Subject: UniStar Nuclear Energy, NRC Docket No. 52-016
Supplemental Response to Request for Additional Information for the
Calvert Cliffs Nuclear Power Plant, Unit 3,
RAI 330, Ultimate Heat Sink

**Supplemental Response to
NRC Request for Additional Information,
RAI 330, Question 09.02.05-20,
Ultimate Heat Sink,
Calvert Cliffs Nuclear Power Plant, Unit 3**

NRC Feedback on UNE's Response to RAI 330, Question 09.02.05-20

Figure 9.2-9— {UHS Makeup Water System}

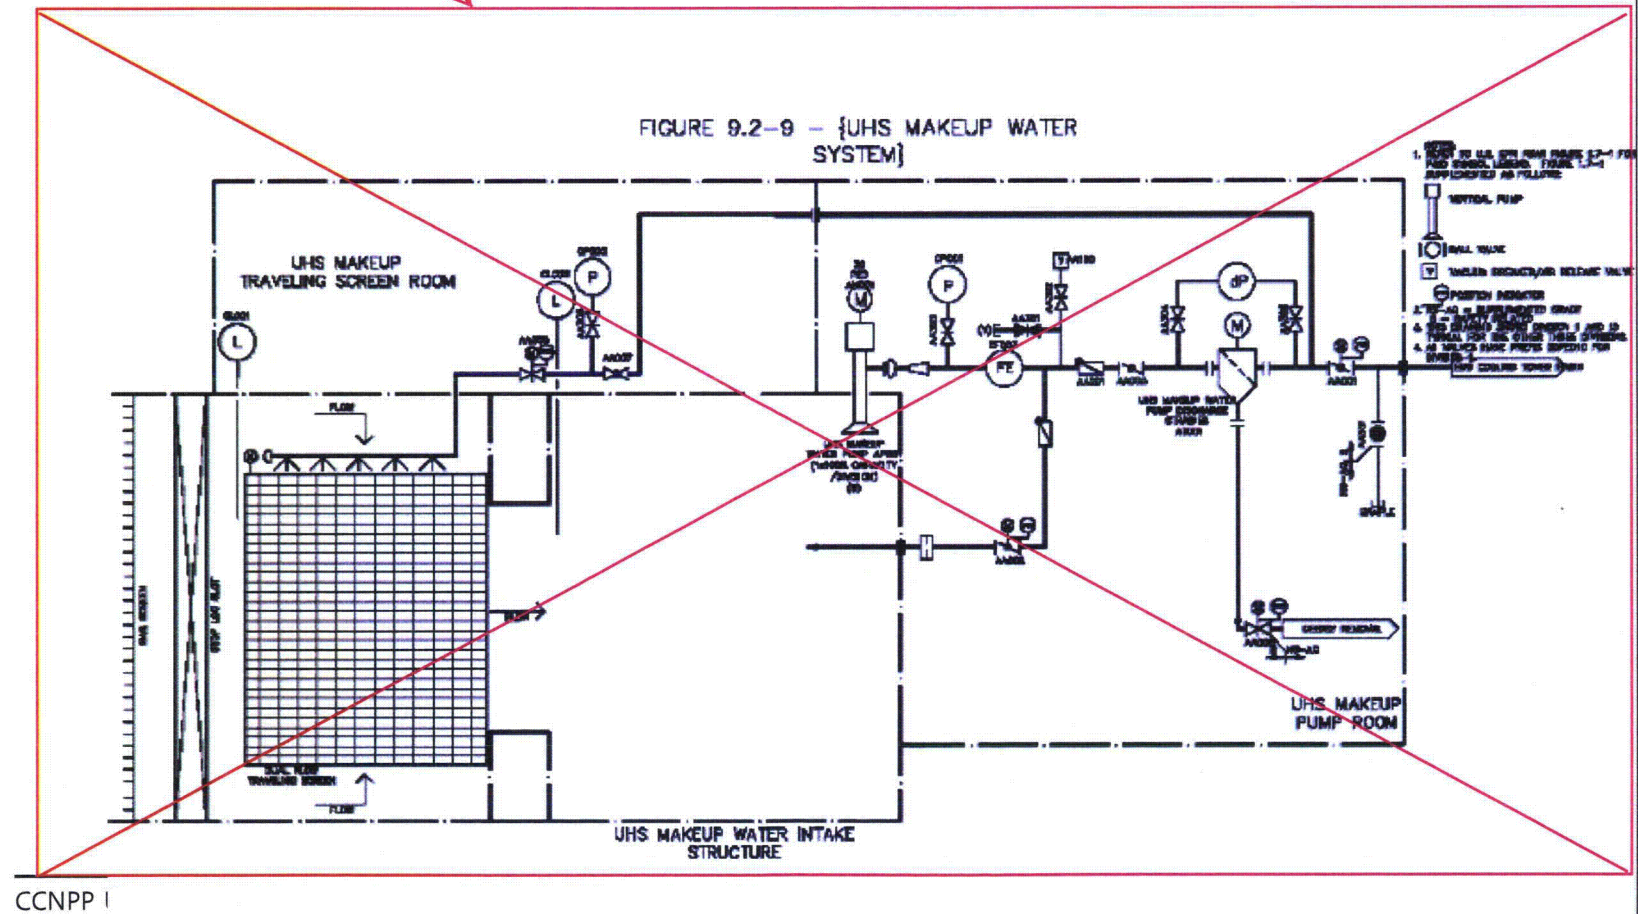
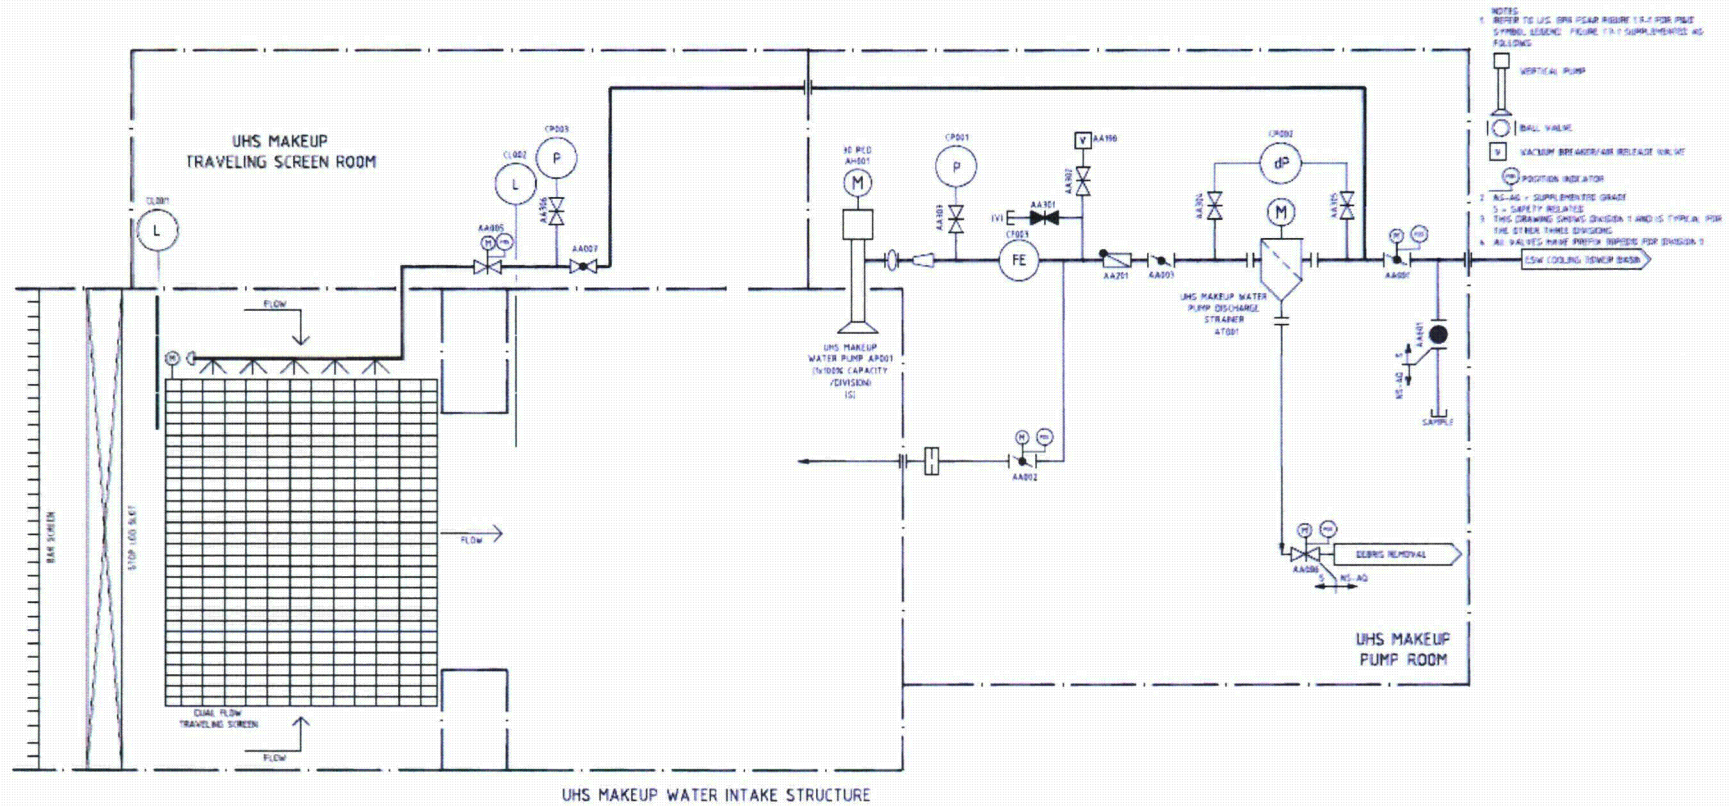
Comment: Page 96/137 [Enclosure 2 of UN#12-153¹] – check valve missing #.

Comment: Page 96/137 [Enclosure 2 of UN#12-153¹] – dP missing #

Response: FSAR Figure 9.2-9 has been revised to remove the check valve on the pump minimum flow recirculation line that is no longer required.

Response: FSAR Figure 9.2-9 has been revised to include the tag number CP002, for the UHS Makeup Water Pump Discharge Strainer Differential Pressure Measurement Instrument.

Figure 2.4-1— {Ultimate Heat Sink Makeup Water System Functional Arrangement}

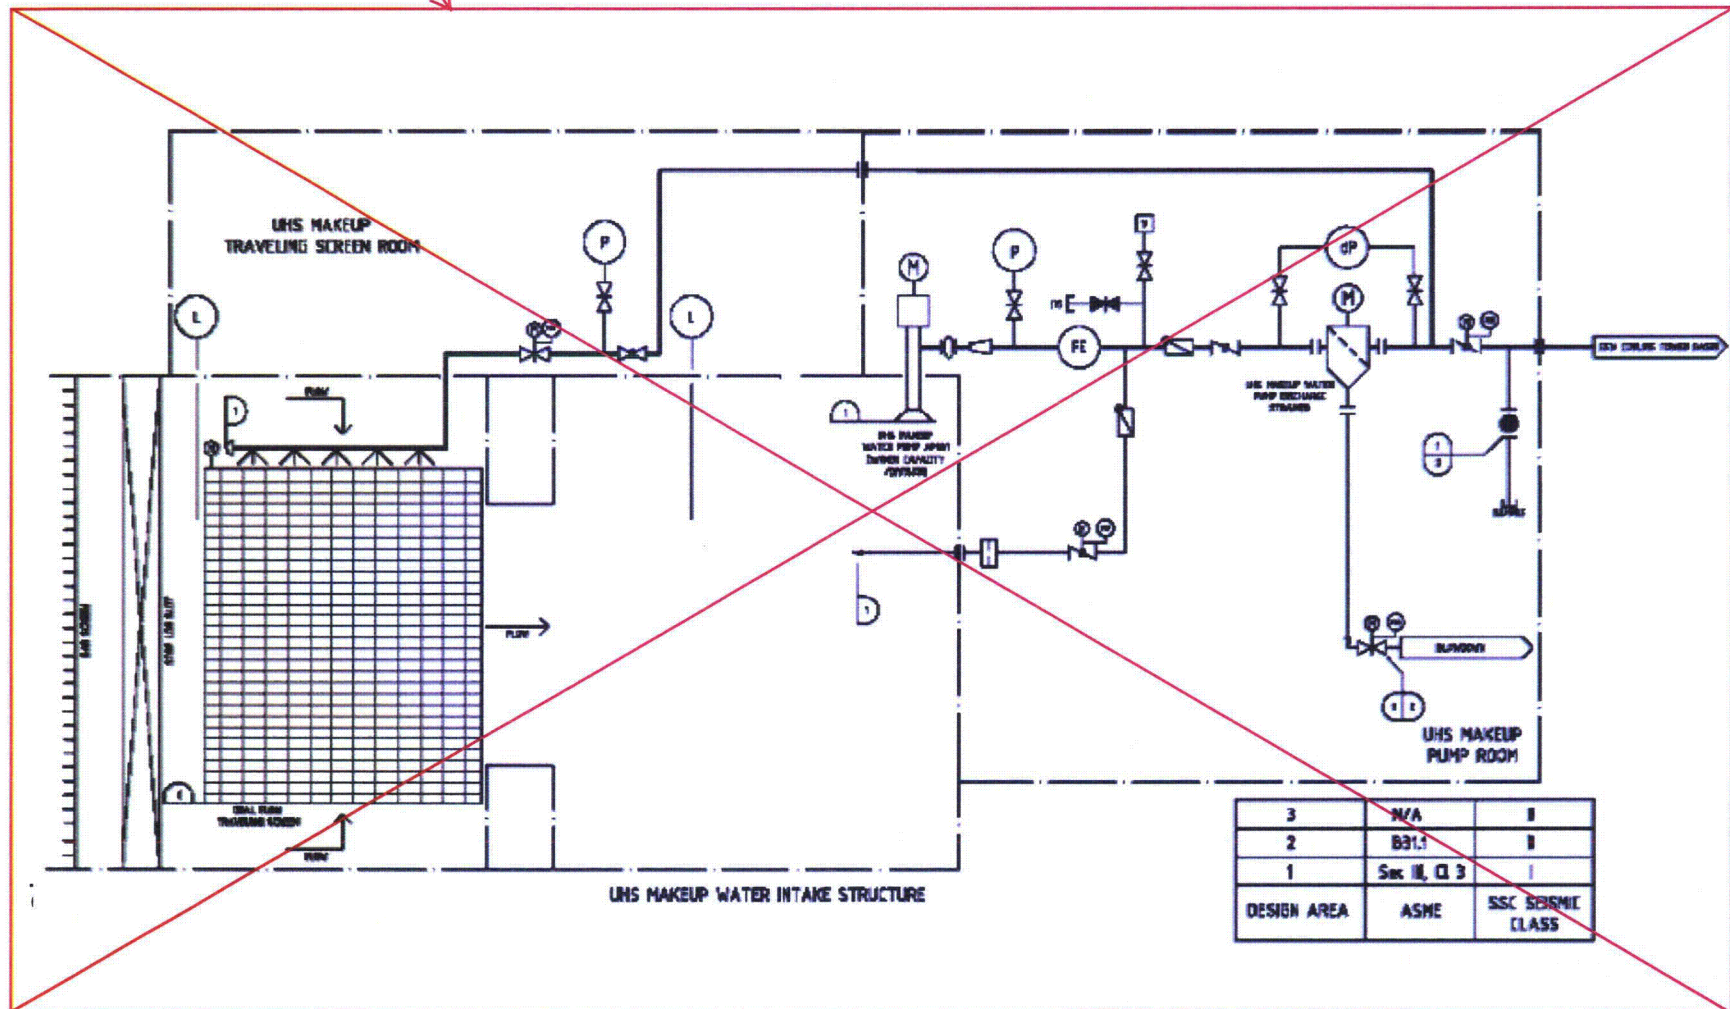
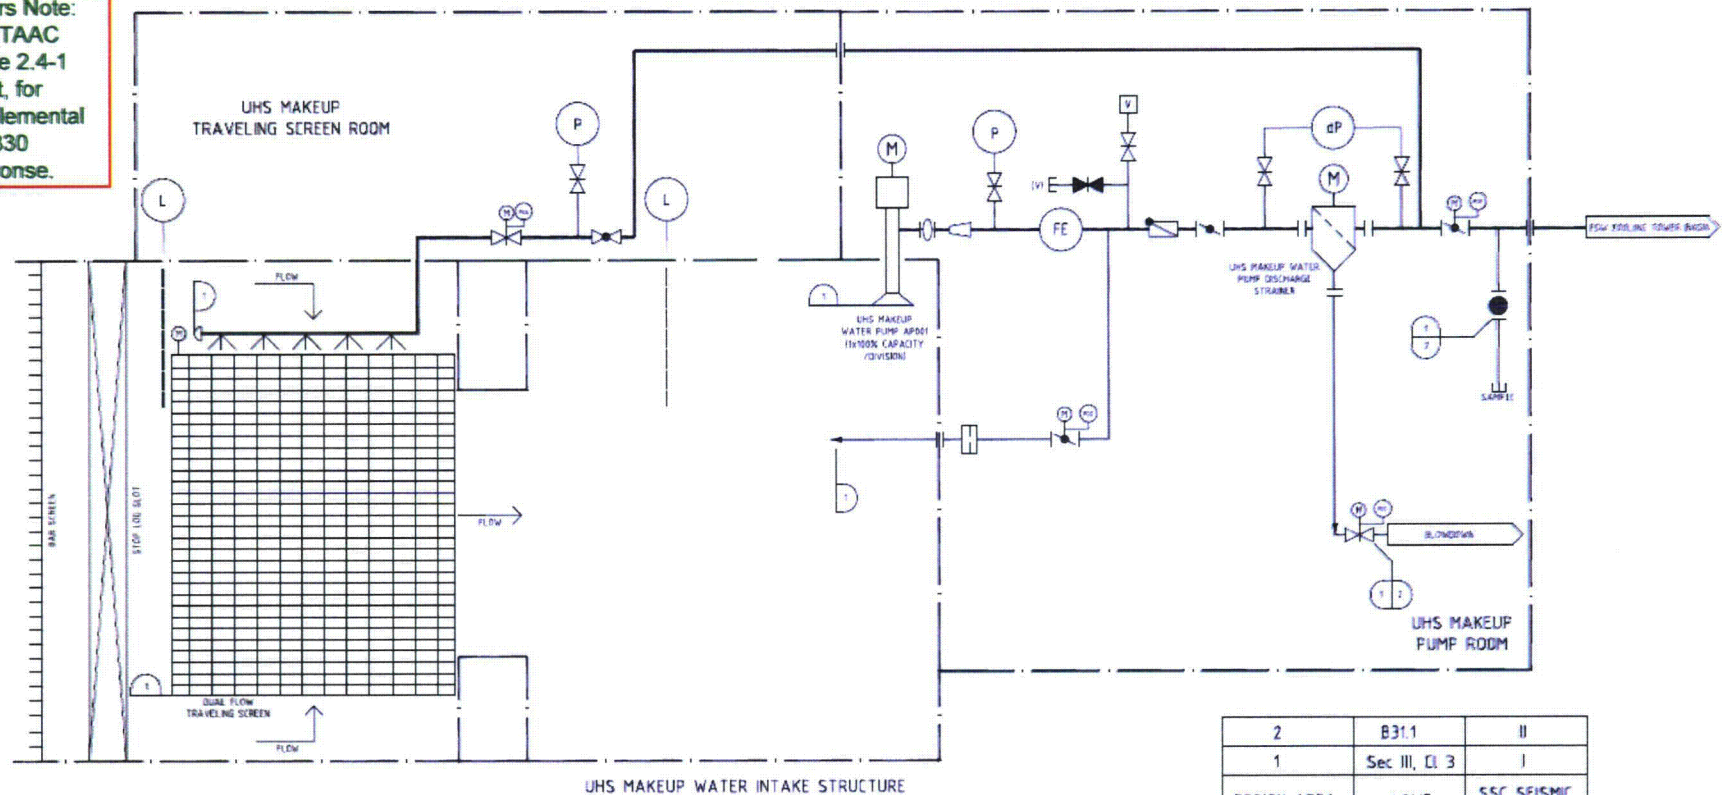
Comment: Page 136/137 [Enclosure 2 of UN#12-153¹] – Table design area “3” – consider deleting since area 3 is not on the drawing.

Response: Inspections, Tests, Analyses, and Acceptance Criteria (ITAAC) Figure 2.4-1 has been revised to remove the ‘Design Area’ classification 3 from the table included in the figure.
